Errata to EPROM Emulator NG, PCB versions 1.6 and below.

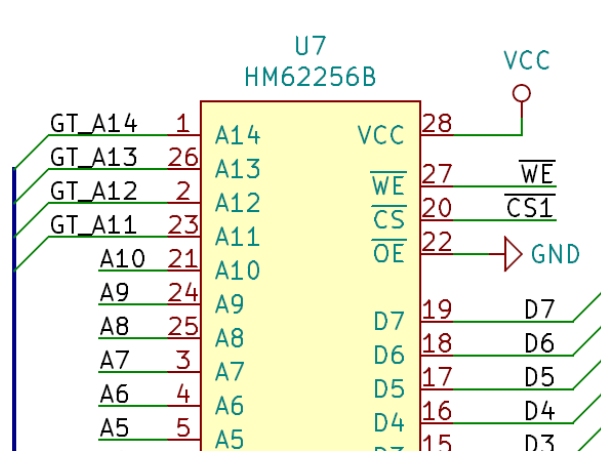
Dear users of the EPROM Emulator NG, I recently discovered a potential flaw in the design of the emulator. Refer to the diagram of the emulator posted to GitHub dated (2020-05-05), parts shown here:

As you can see, the /OE line (pin 22) is connected to ground (GND), permanently enabling the output of the one of the SRAMs at any point of time (the other control line /CS is driven by the state of address line A15). This creates a potential issue, when the emulator is waiting for data from the computer and the shift registers are enabled, driving at the same time the data bus. This situation continues until data from computer or the SPI EEPROM is loaded into SRAM and the “emulation” starts (shift registers get disabled and external buffers - 74HC541 enabled). In my initial design and prototype of the emulator I had those lines correctly connected to the “Reset” signal, this way it guarantees only one of those can be active on the data line at any point, but while I was troubleshooting a completely unrelated issue I disconnected the OE lines from Reset and connected them to GND, I carried over the flawed design to later releases of the PCBs and only just noticed the mistake.

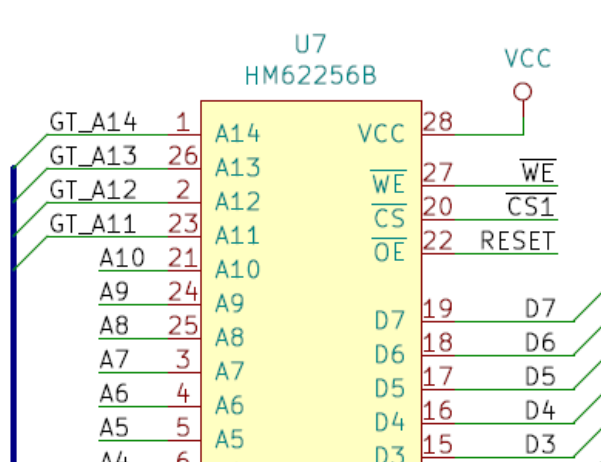
Interestingly this has not caused any functional issue for the many emulators that are currently in use, they are working and serving many of you very well, never the less I will publish updated diagram and new PCB design (1.7), the correct way to connect the SRAM is as follows:

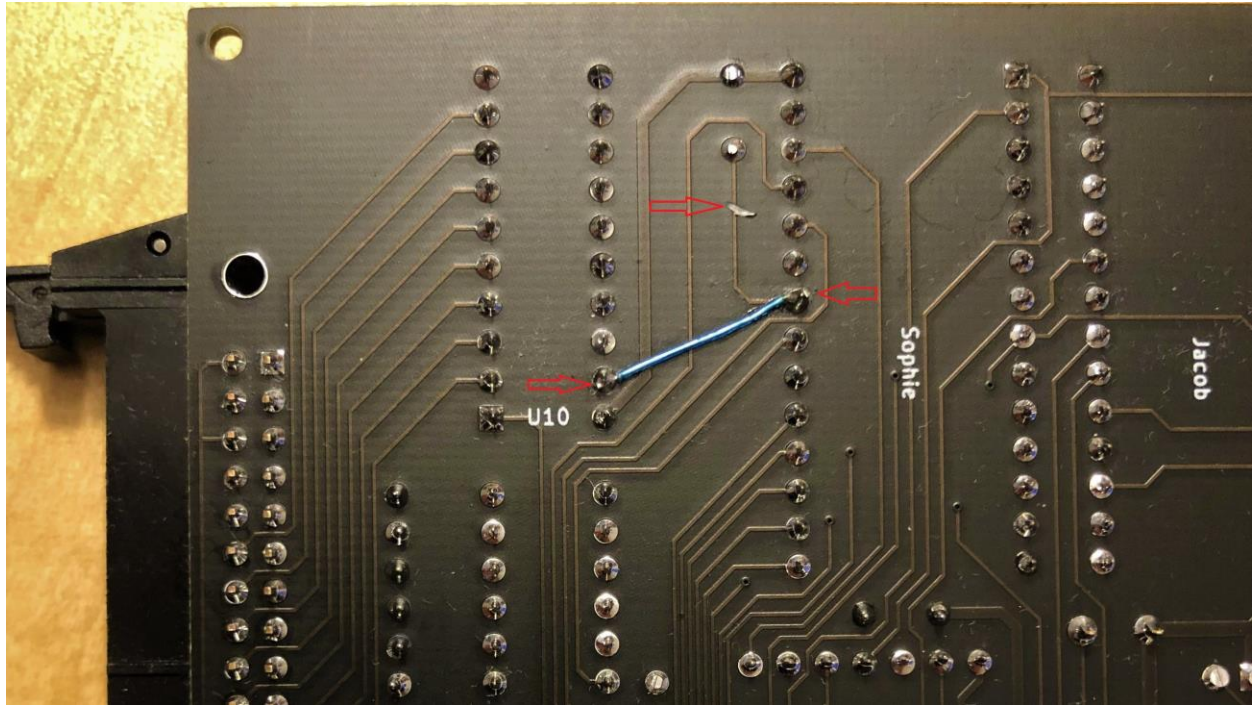
Option A: Hardware modification of the PCB: very simple, cut one track to separate the /CS line from GND, and run a short link of wire to connect the /CS to RESET:
